Date: November 30, 2022
To: Dealer Principal, General Manager, Service Manager, North American Dealer Network
From: Richard Kenton, Technical Director Dan Schwartz, Service Area Manager

We would like to inform you that the new Rear Shock Absorber Protector **part no. 4601N841A** has been introduced into the production line as of September 13<sup>th</sup>, 2022, starting from frame number ZDM1X00AAPB004049.

This Workshop Campaign is to extend the possibility of installing the new Rear Shock Absorber Protector on Desert X models manufactured before the above-mentioned frame number. In order to carry out this upgrade, the following components must be ordered in the quantities indicated:

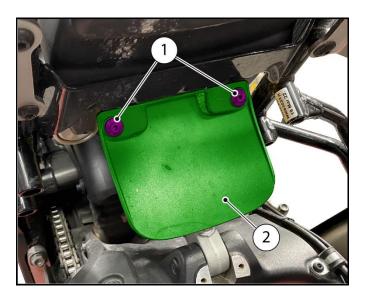
- 1. Position the motorcycle on the rear paddock stand.
- 2. Remove the 2 screws M5x9 (1) and remove the rear mudguard (2).

The **2 screws M5x9 (1)** will be reused to mount the rear shock absorber protector.

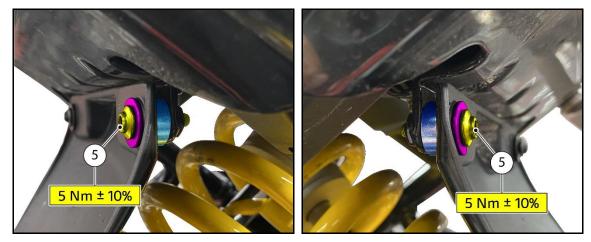
**3.** Reinstall the **rear mudguard (2)** with the **2 screws M5x20 (5)**, **2 spacers (6)** part no. 71614291AB and **2 spacers (7)** part no. 71314111A, as shown in the figure.

4. Tighten the screws M5x20 (5) to a torque of <u>5 Nm ± 10%</u>.

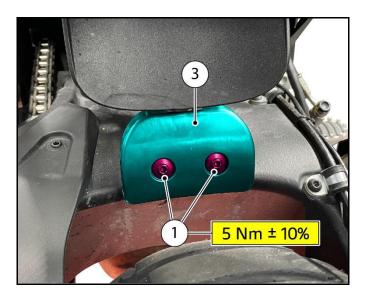
Before positioning the rear shock absorber protector, carefully clean the inside of the holes for the protector fixing screws.

Clean the threads of the M5x9 screws previously removed from the rear mudguard and apply Loctite 243.

Position the rear shock absorber protector (3) with the 2 M5x9 screws (1). Tighten the screws M5x9 (1) to a torque of <u>5 Nm ± 10%</u>.
